Office Action Summary

10/814,877

CAVENEY ET AL.

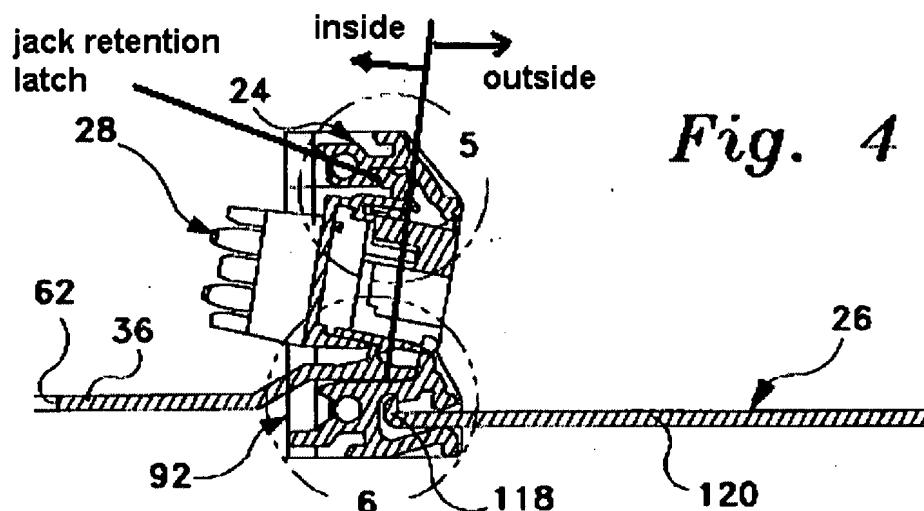
Curry, as modified, discloses substantially the claimed invention except for mounting opening accommodating two jacks. Gutierrez teaches mounting openings

accommodating two jacks in order to simplify the faceplate construction. Therefore, it would have been obvious to a person of ordinary skill in the art at the time the invention was made to form the mounting openings accommodating two jacks, as taught by Gutierrez, to simplify the faceplate construction.

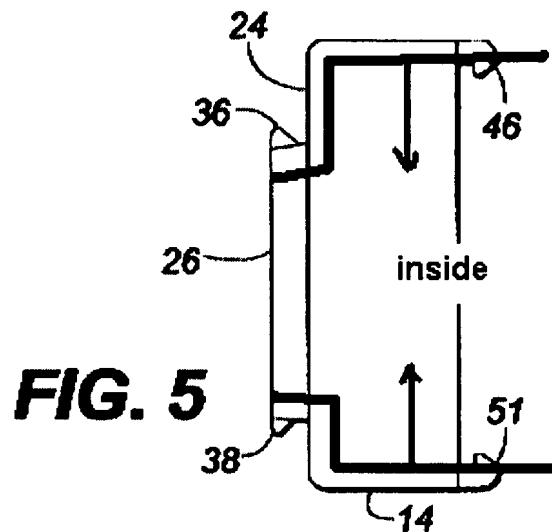
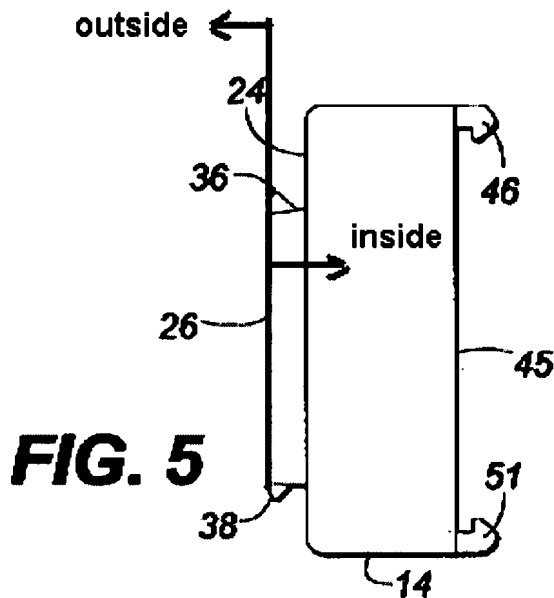
In response to Applicant's argument that Sanchez does not disclose "a faceplate having a plurality of mounting openings and each mounting opening having at least one modular jack retention latch protruding within the mounting opening", please note that element 44 is a retention latch, and protrudes within mounting opening 32. Please note that the mounting opening is not limited to that portion in the front of the jack holder, but it extends backwards from the front face. Additionally, the fact that portion 44 is not part of the jack holder does not preclude it from being a retention latch. Element 44 protrudes within the mounting opening (see following figure).

Additionally, element 44 retains the modular jack to the faceplate 14, thus it is a modular jack retention latch.
